# Anker Innovations Limited

Request of Class II Permissive Change

**FCC ID: 2AOKB-T8591**

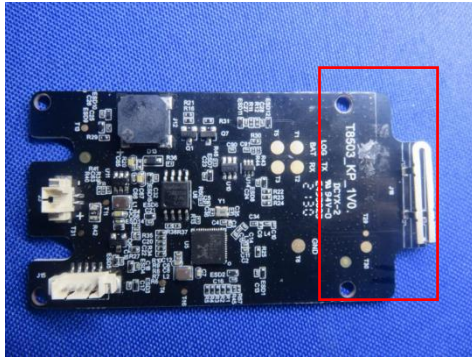
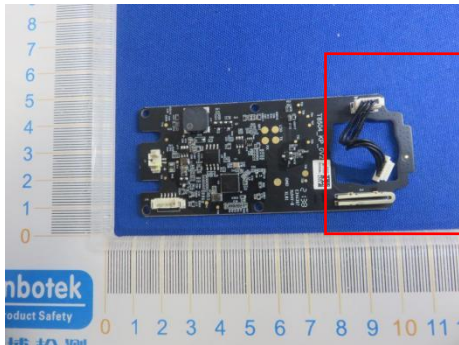
Remark: This is a Class II application of the device, the difference between the original device and current one described as following:

- (1) Changing the Product Name to "eufy Security Smart Lock R20".
- (2) Product function only adds fingerprint recognition and only changing the PCB layout and shape for this part.
- (3) Changing the antenna position, and change the antenna gain to 1.82 dBi.

The changes are not related with the other RF parameters, only spurious emission were retested, the conducted power quotes the data of the original report 18220WC10182601.
